TECHNICAL NOTE

Subject: **Fordley Hall – Deadline 6 Submission Noise**

**FORDLEY HALL – SIZEWELL C LINK ROAD
Construction And Operational Noise Assessment**

Reference: BD/VL/P21-2329/02

Chart 5.1: Noise Monitor Results

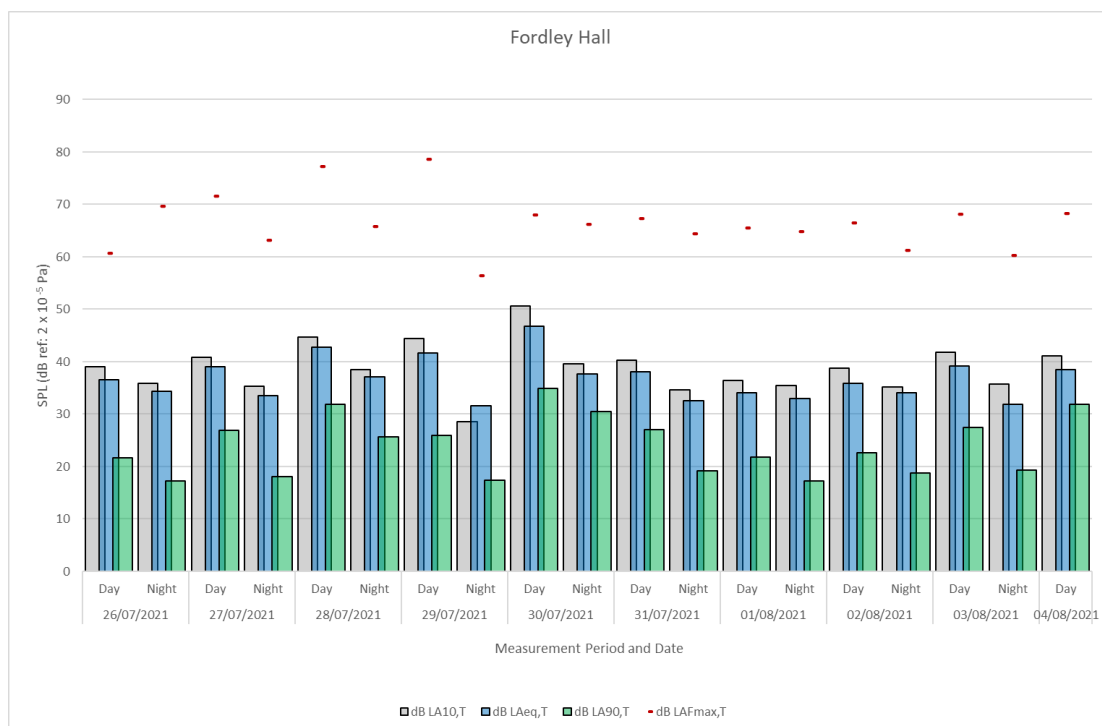
- 5.3 As can be seen in the table and chart above, the ambient levels remained very low, which is expected for this largely rural location. The most commonly occurring daytime ambient sound level at this location was $\approx 38\text{--}39$ dB $L_{Aeq,1hr}$ and the daytime background sound level ranged between 22 and 35 dB $L_{A90,Day\ Time}$. The night time background sound levels were far lower, between 17 and 27 dB $L_{A90,Night(8\ hours)}$, but with a most commonly occurring background sound level of 17 dB $L_{A90,1hr}$.

Figure 5.1: Measurement Location Excerpt from Book 6, Volume 6, Chapter 4, Figure 4.2

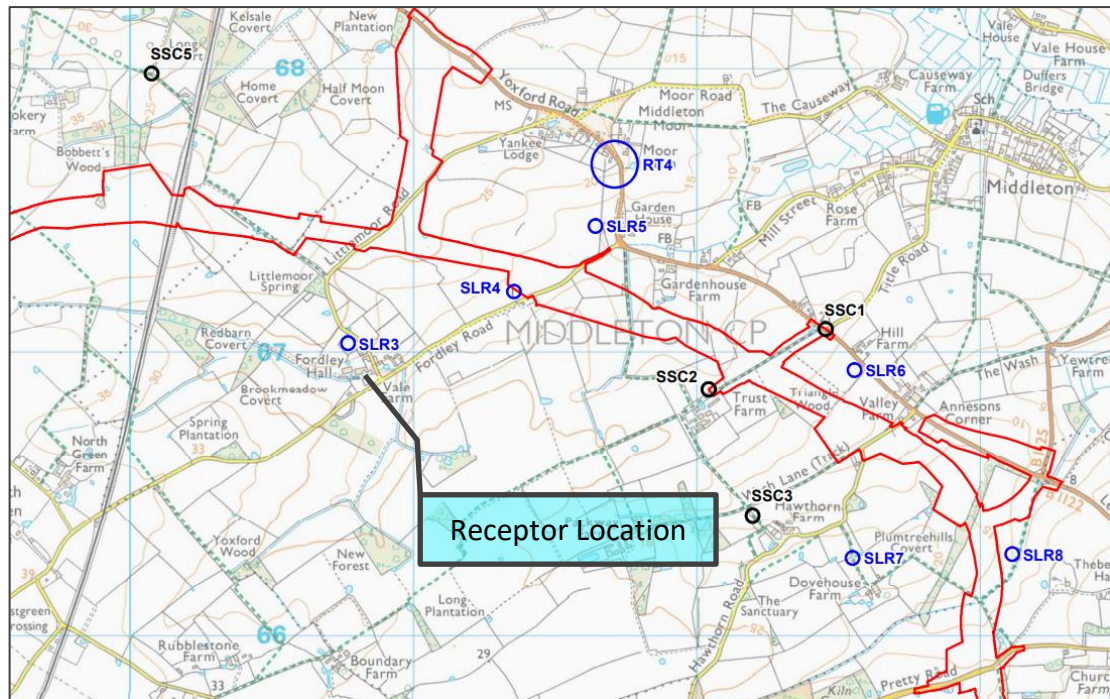
- 5.4 The most representative monitor location in the EDF ES for the Fordley Hall residence NSR would be SLR 3, which was stated to be a typical measured daytime level of 45–47 dB $L_{Aeq,T}$. (Table 4.13, Book 6, Volume 6, Chapter 4). A detailed analysis of the measured sound levels was included within Book 6, ES Volume 2, Chapter 11, the Noise and Vibration Baseline Report.
- 5.5 Within the submitted document, the baseline sound levels were in 6–8 dB excess to those from the Create baseline sound monitoring for the daytime, and the background sound levels were significantly higher.
- 5.6 Presumably the considerable difference was due to the reliance on two individual thirty minute measurements during the day and a single one hundred and twenty minute measurement at night time.
